Problem Report

Report Number: 5

Project Name: TeraPixel APS for CALICE **v1.1**

Item: Configuration Registers: Power droop in buffer supplies

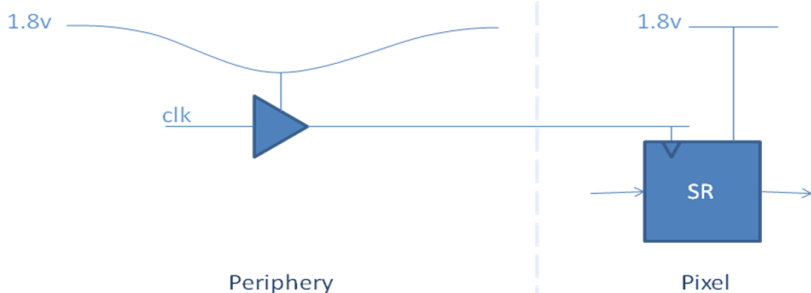
Problem
<ul style="list-style-type: none"> • Were reporting many errors and not holding the correct data • Problem due to different power domains and high loading of “slow” clock drivers  <p>The diagram illustrates a clock signal path between two power domains. On the left, labeled 'Periphery', a blue triangle represents a clock buffer. It is connected to a 1.8v power supply. A signal line labeled 'clk' originates from the buffer. On the right, labeled 'Pixel', a blue square represents a Shift Register (SR). It is also connected to a 1.8v power supply. A vertical dashed line separates the 'Periphery' and 'Pixel' domains. The 'clk' signal line crosses this boundary to connect to the SR register.</p>
<p>Originator (Sign/Date)</p> <p>JC</p> <p>Project Manager (Sign/Date)</p>
Remedial Action
<ul style="list-style-type: none"> • Fixed by driving one of the power domains at 1.6v (previously 1.8v) • Implemented using the power module developed for TPAC1.0 with updated resistor values and driving VDD1V8sram through J7 • Proved, reliable fix provided 2% tolerance on resistors on power module board.
